Bulletin No.: PIT5209A

Subject: Unwanted Alarm Sounding (GM Accessory Inclination Sensor Mounting)

Models: 2007-2014 Cadillac Escalade Models

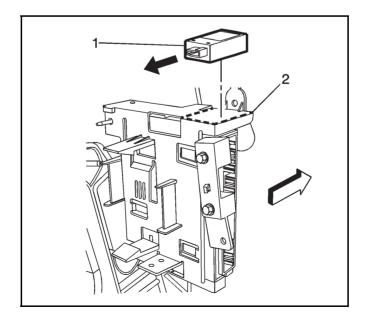
Some owners may comment that for no reason the alarm will go active. This would normally occur after the vehicle has been sitting awhile following a drive cycle. The sensor was originally positioned on the driver's side lower HVAC duct. With thermal cycling the duct could expand and contract enough that, depending on exact sensor location, movement of the duct might cause the sensor to trip and activate the alarm.

To verify the alarm was activated by the inclination sensor, use the Tech 2 and build as follows: Body > Body Control Module > Data Display > Theft Data. View the three parameters for "CTD Trigger History" to see what triggered the alarm. If the trigger is the inclination sensor, inspect the sensor's mounting location. If it is attached to the driver's side lower HVAC duct, it will need to be relocated. The location of the sensor placement has been updated to the top of the BCM bracket. See picture below. Relocate the sensor to the top of the BCM bracket as shown in the attached:
